BLUE BIRD

R07MS

Service Bulletin 34273

Instructions for Braun Corporation "Public and Private Use" Dual Parallel Arm Lift Threshold Sensitivity Evaluation and NHTSA Compliance Applicable for NL, NCL and NVL Series Lifts

Threshold Sensitivity Test

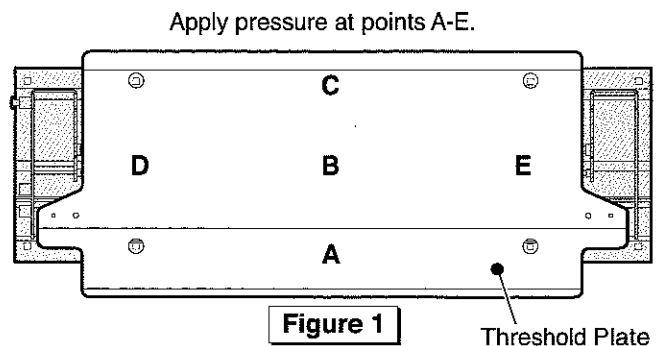
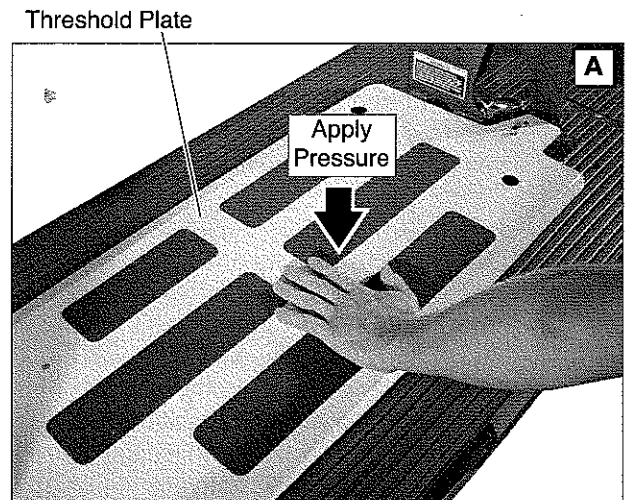
1. Turn Lift Power switch ON. Deploy the lift platform fully to the ground.
2. Apply hand pressure on the center of the threshold plate as shown in Photo A. The visual and/or audible threshold warning* should be activated when you push down.

Repeat the sensitivity test procedure at positions A-E shown in Figure 1.

3. If the threshold alarm is activated at all positions, no further procedures are required. The lift threshold sensitivity meets NHTSA FMVSS 403/404 requirements.

If the threshold alarm is not activated at all positions, perform the retrofit procedures detailed on pages 2 and 3 of this bulletin. Repeat the sensitivity test procedures following the retrofit. If the lift still does not meet the requirement, contact a Braun Corporation Product Support representative at 1-800-THE LIFT[®].

Threshold Sensitivity Retrofit Instructions

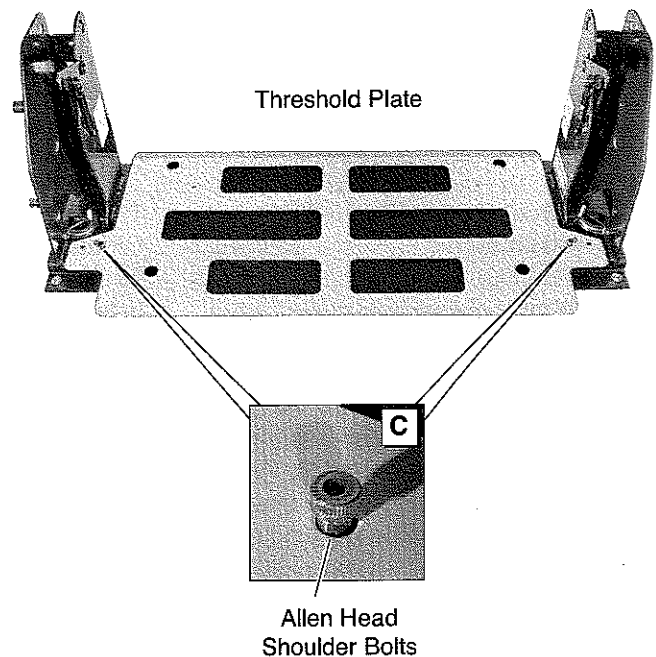
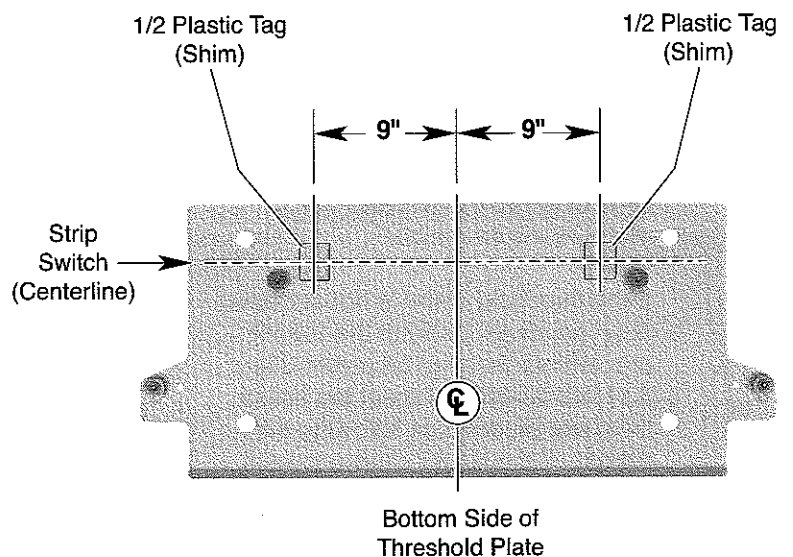
Turn threshold plate over. See Photo D. The strip switches typically leave an impression (mark) on the yellow plate from use. Use the impression of the inboard strip switch as a centerline for shim positioning (or measure to establish position).

Position each shim 9" from the center of the threshold plate (see Photo D). Align the tags with the strip switch centerline. Clean the surface as detailed below and affix the adhesive-backed tag to the plate (**press firmly**).

Threshold Sensitivity Retrofit Instructions

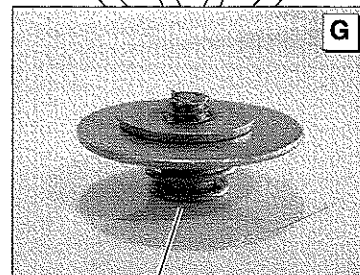
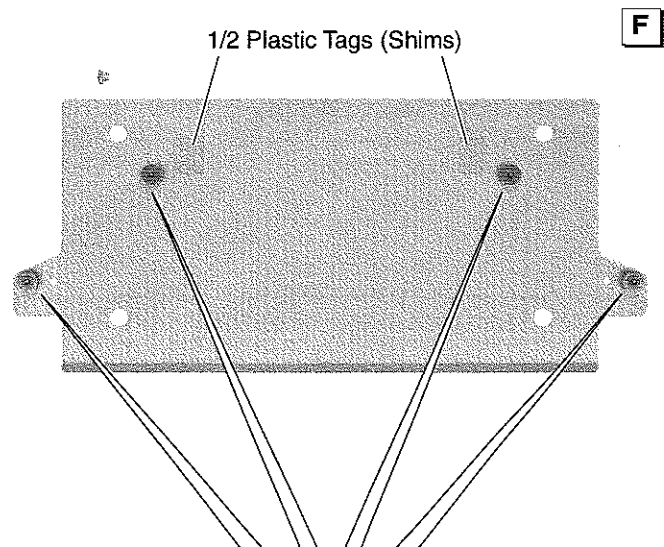
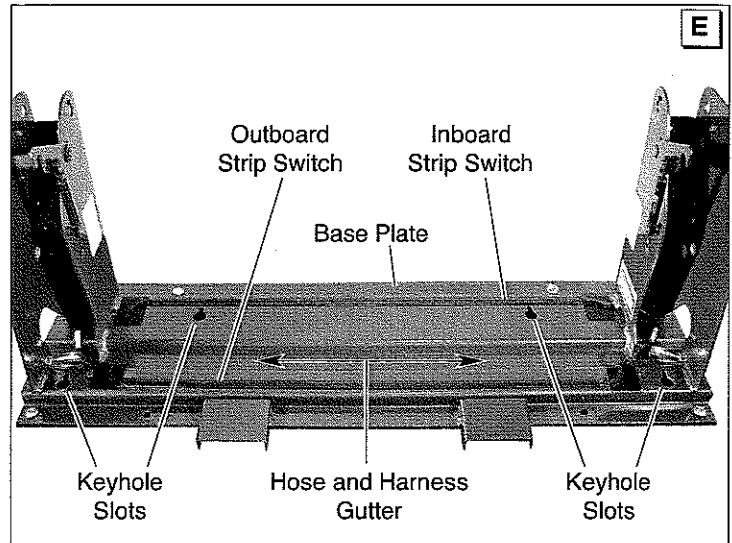
4. Reposition the threshold plate (with shim). Align the keeper standoffs (studs) on the bottom of the threshold plate with the base plate keyhole slots. See Photos E, F and G. Insert studs and **carefully** slide the plate inward (engage slots fully).

Ensure all hoses and wiring harnesses routed through the base plate gutter are positioned fully in the gutter and not located anywhere they could potentially interfere with activation of the tape switches. See Photo E.

Note: Spraying a light mist of glass cleaner (or other) to the strip switches will aid in the plate sliding easier into position. See Photos E, F and G.

Ensure all four keeper standoffs engage the base plate keyhole slots.
